Case File Number: PLN 18030

Proposal: The proposal is for new construction for an Aspire K-8 Charter

SUMMARY

CITY OF OAKLAND PLANNING COMMISSION

NORTHWEST ELEVATION- FOOTHILL AVE & 67TH AVE

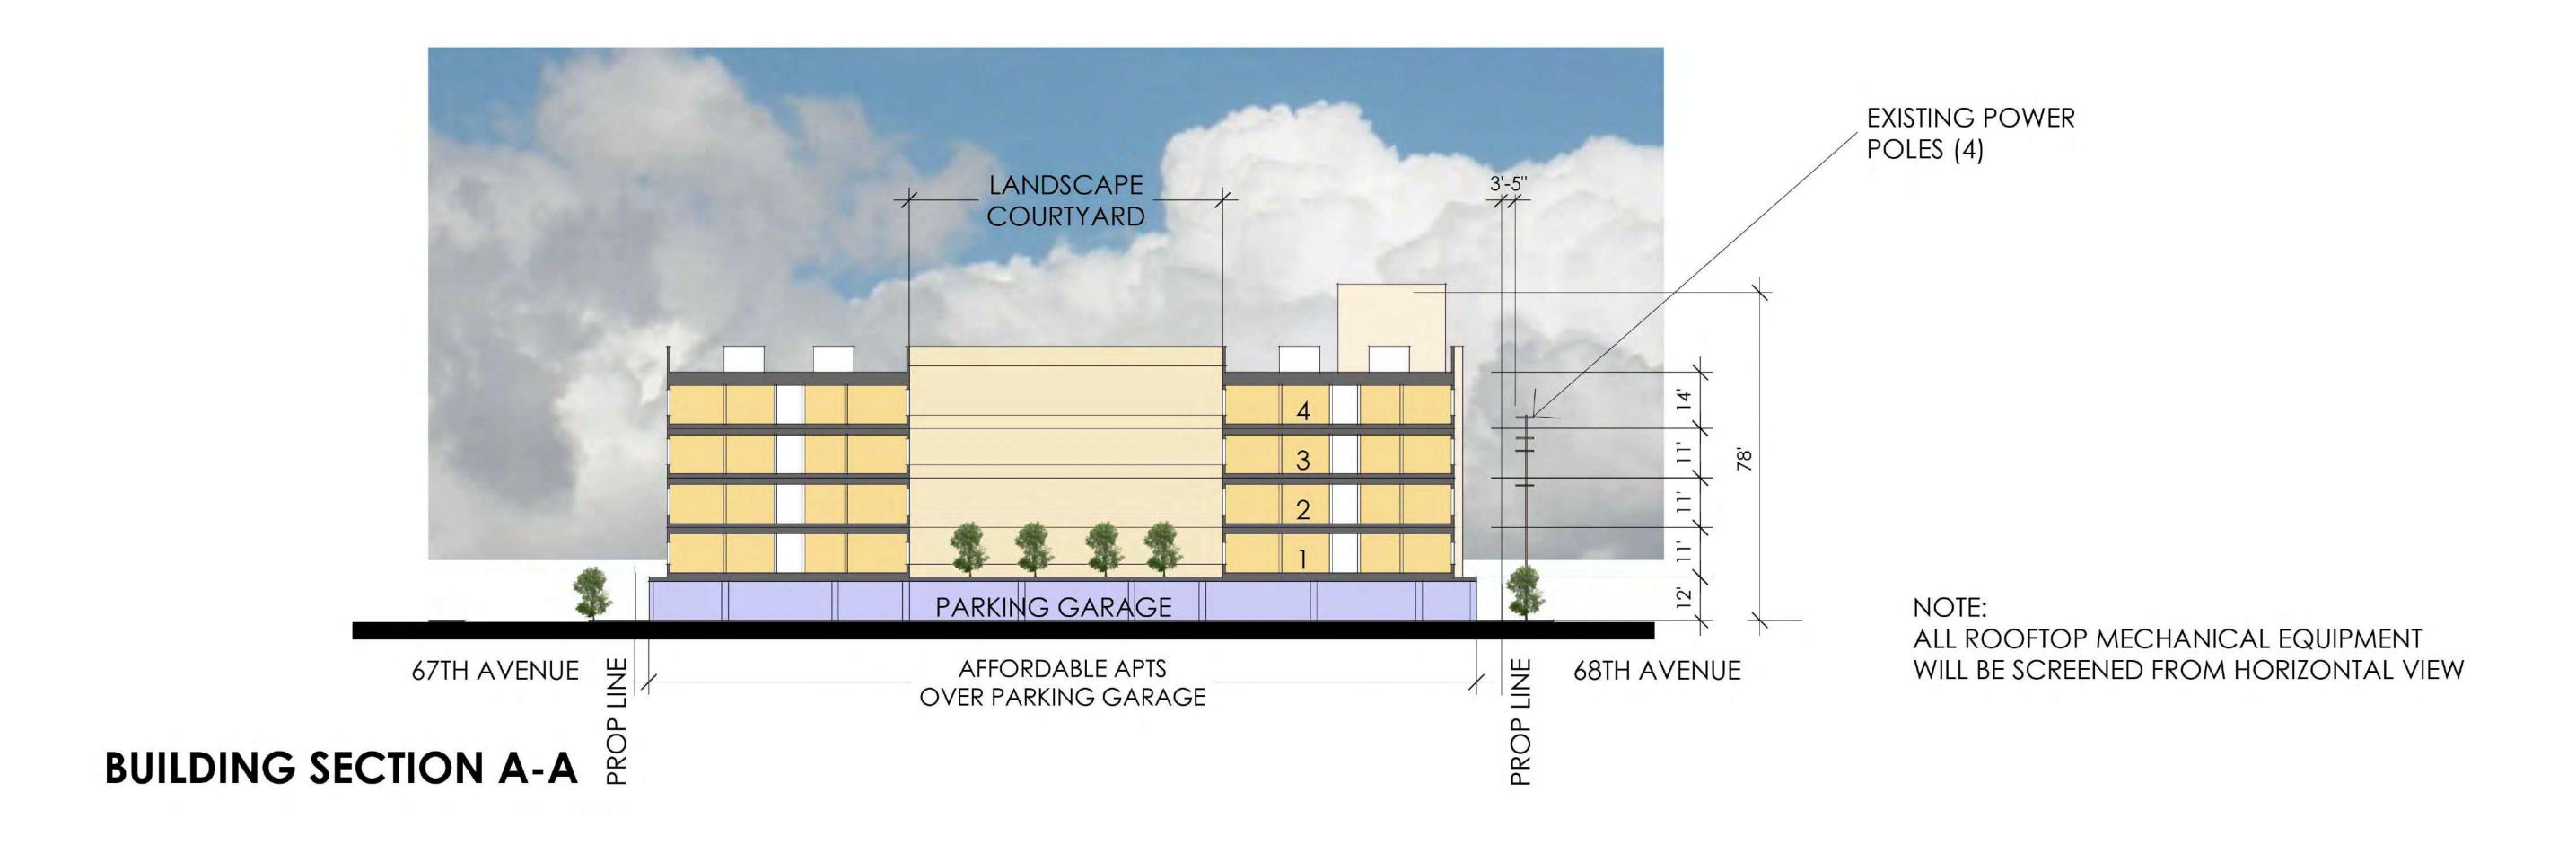
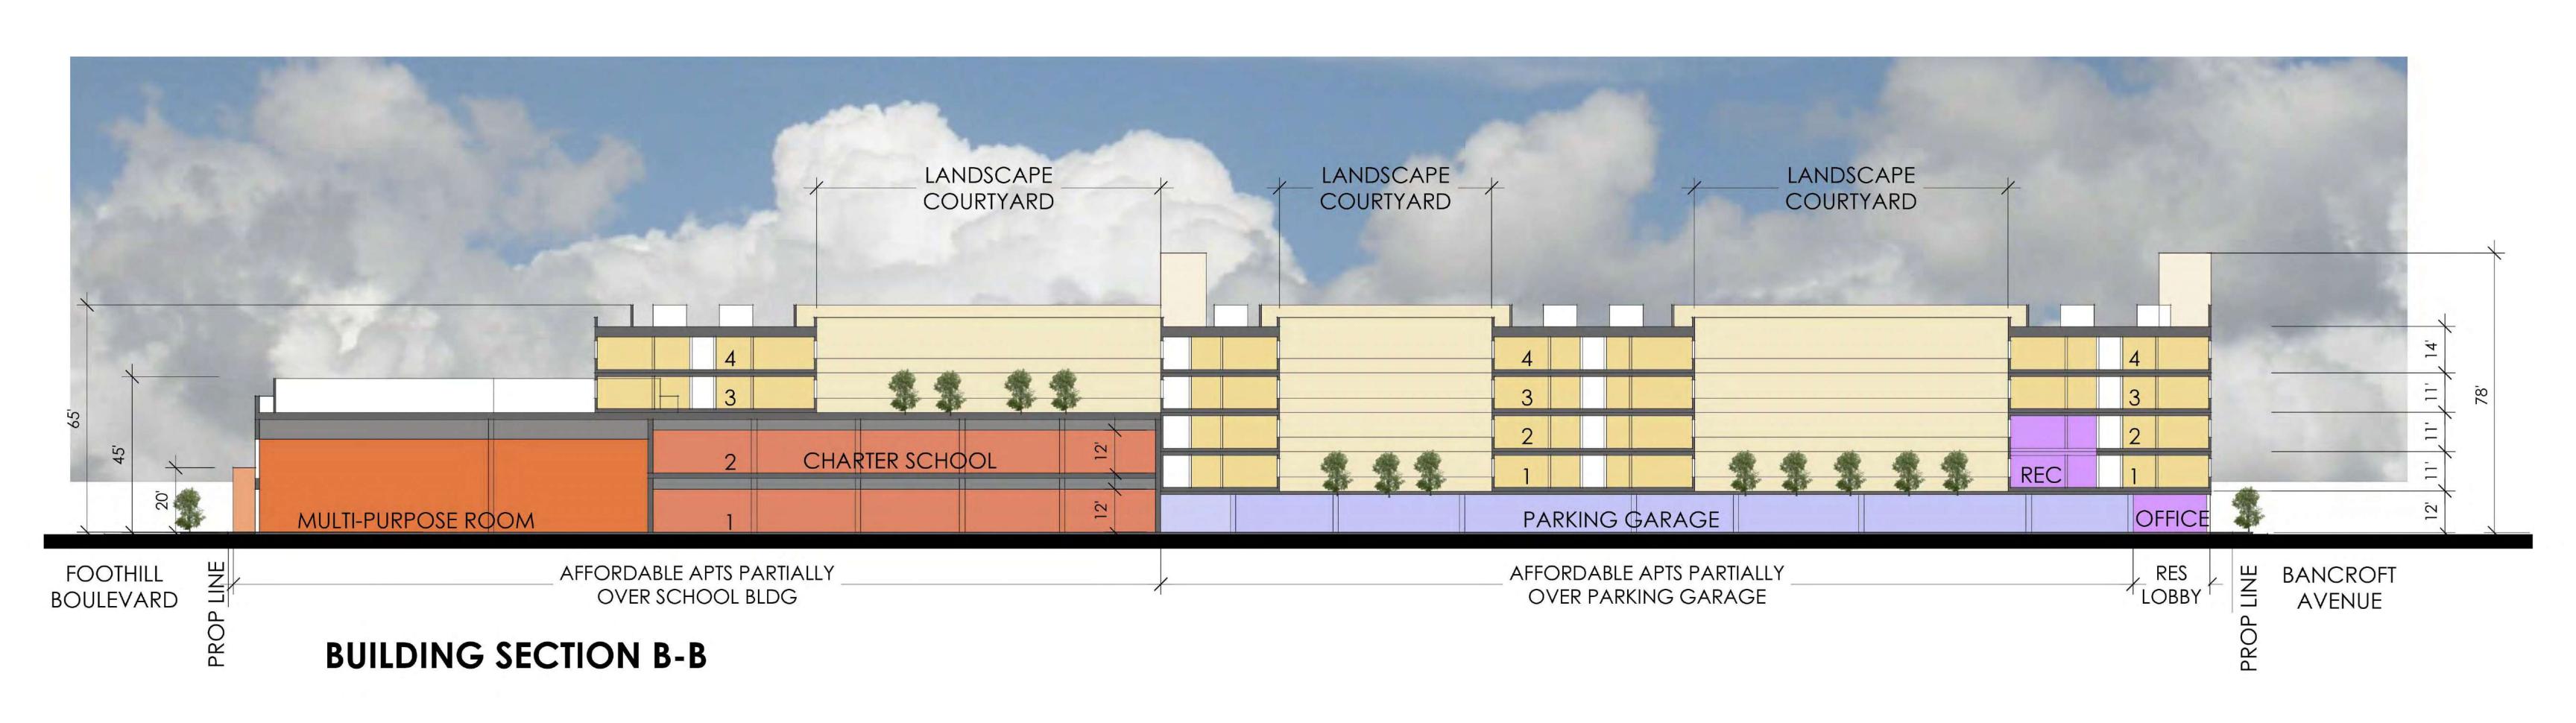
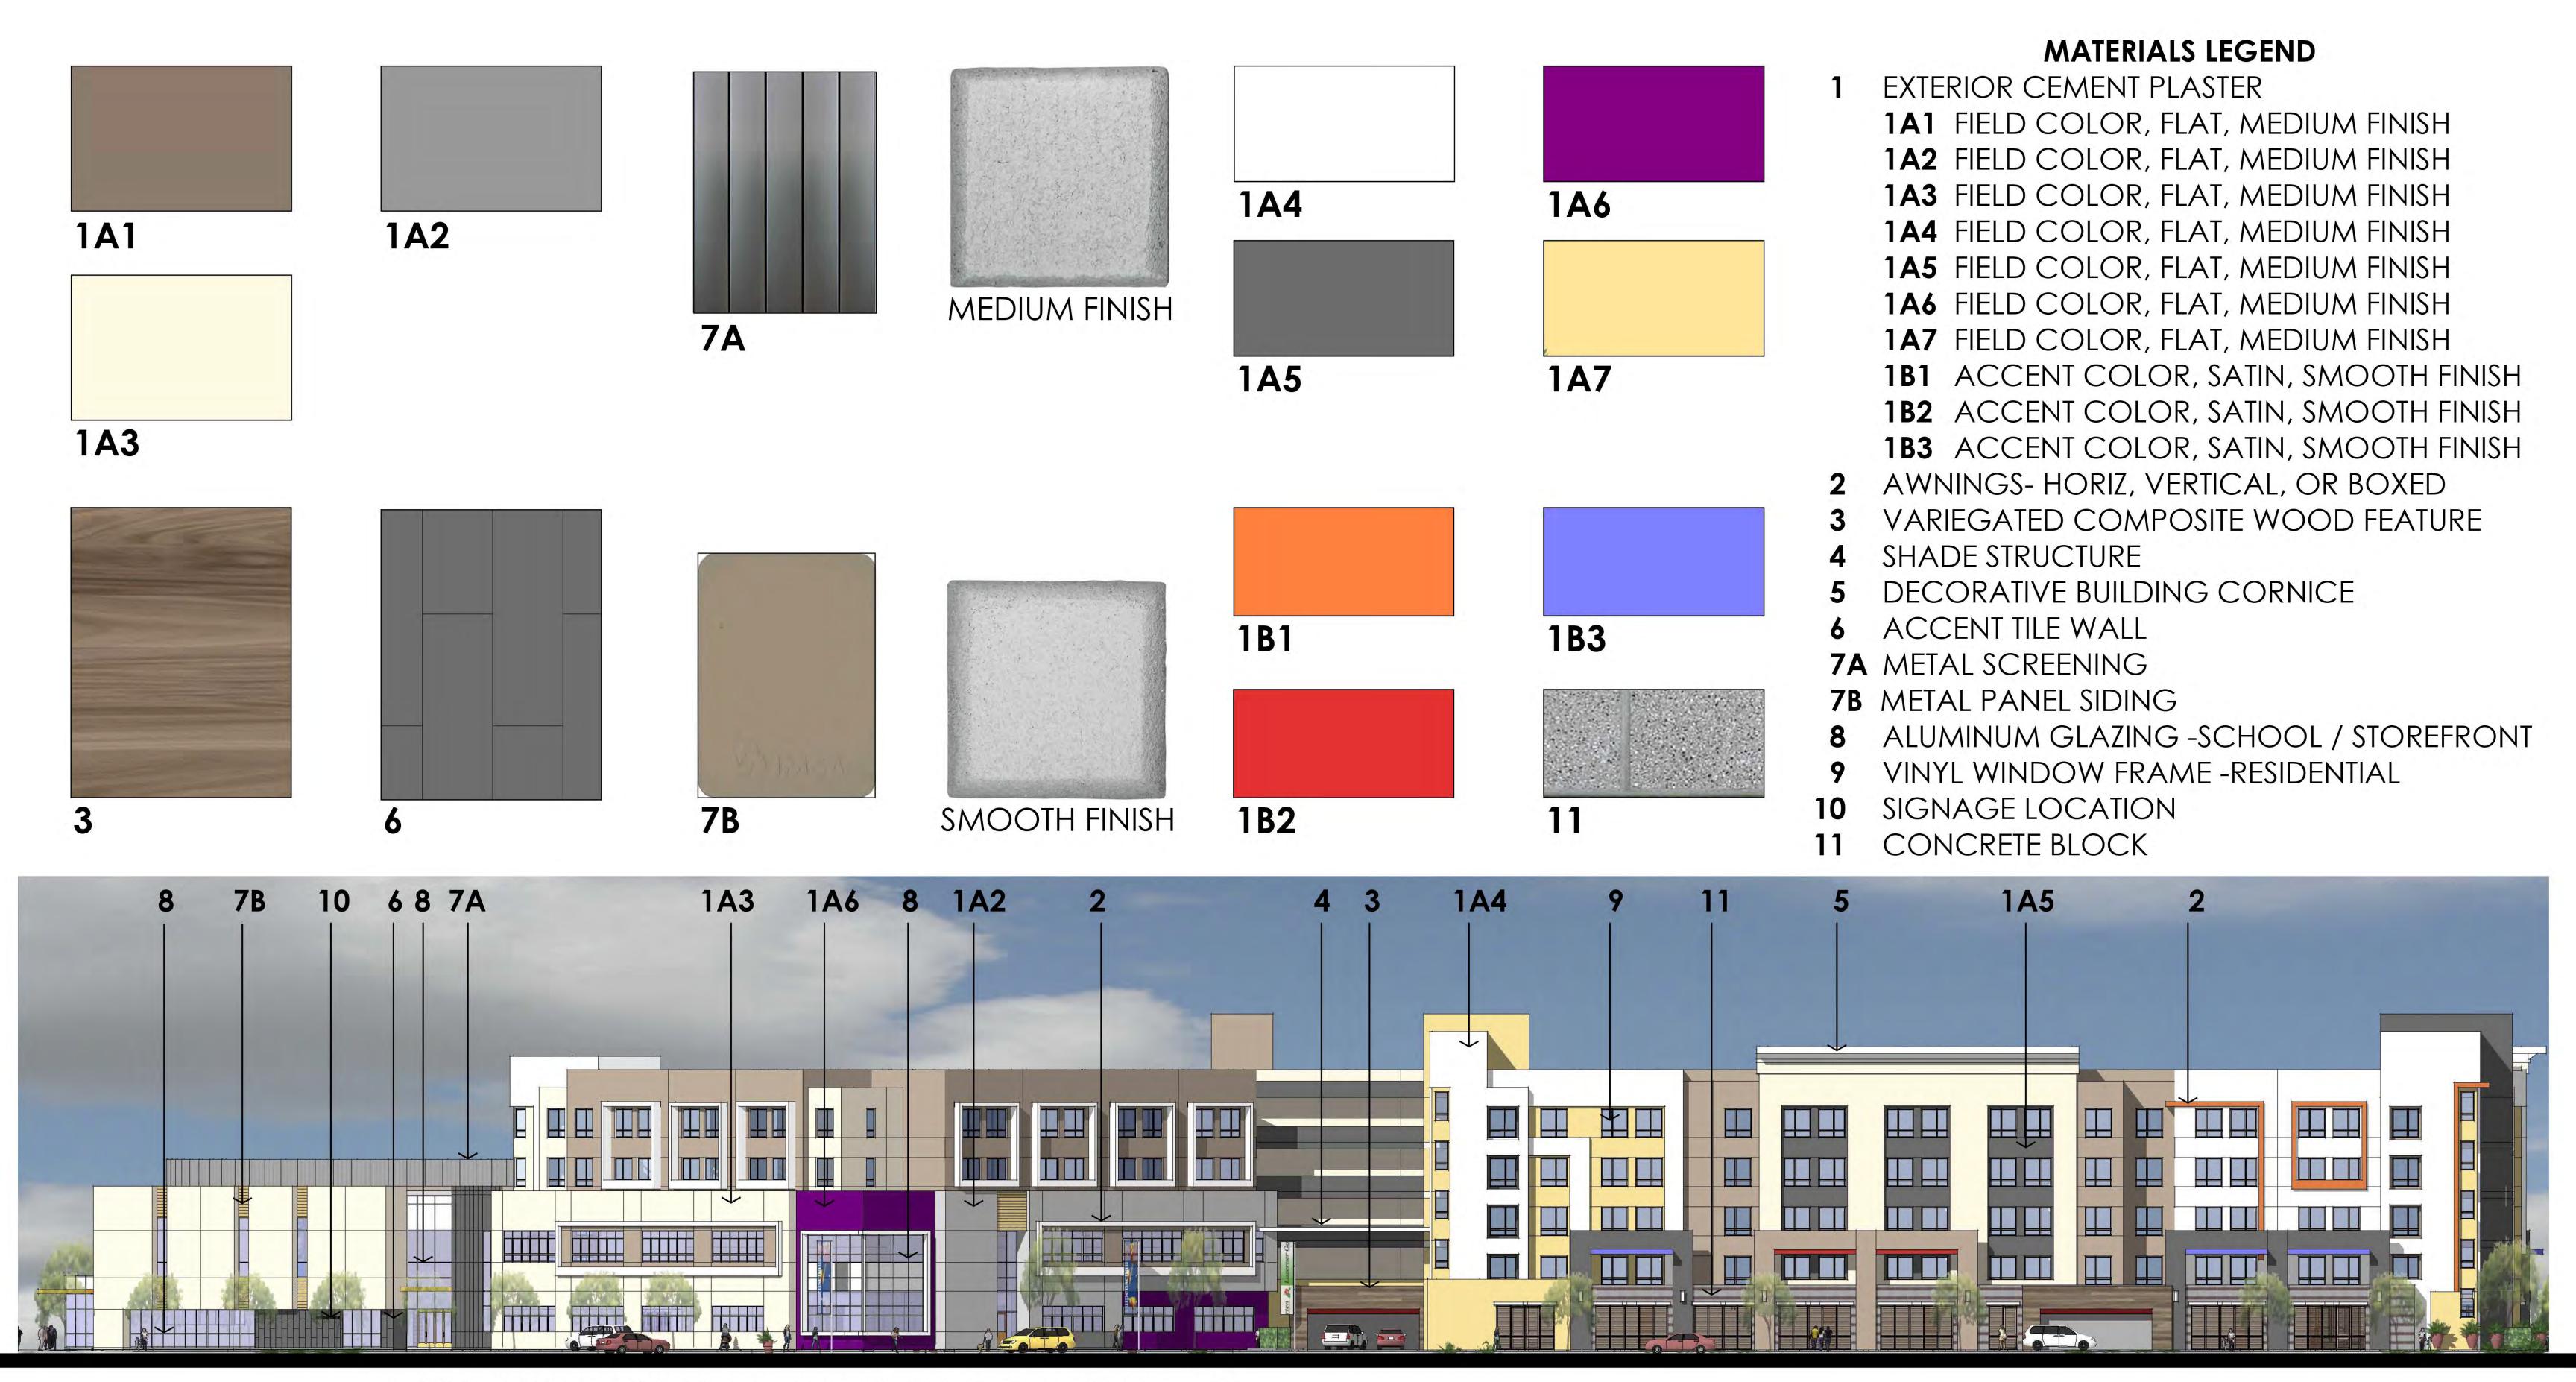
• Transparency on Foothill: The school portion of project is designed with the main school entry on Foothill Blvd approximately at mid-block with classrooms extending to 67th Street. A gymnasium is located along Foothill Blvd.

The civic use is permitted in the CC-2 zone although the Commercial Corridor Design Guidelines envision active storefront activity along this corridor. Staff has been working with the applicant on design concepts that can maximize transparency and street activity. The applicant has presented a design concept that provides additional transparency on this frontage and brings the overall building façade into compliance with the 55% transparency standard. Direction is requested as to whether the additional transparency would be more effective at the street level or on the upper stories.
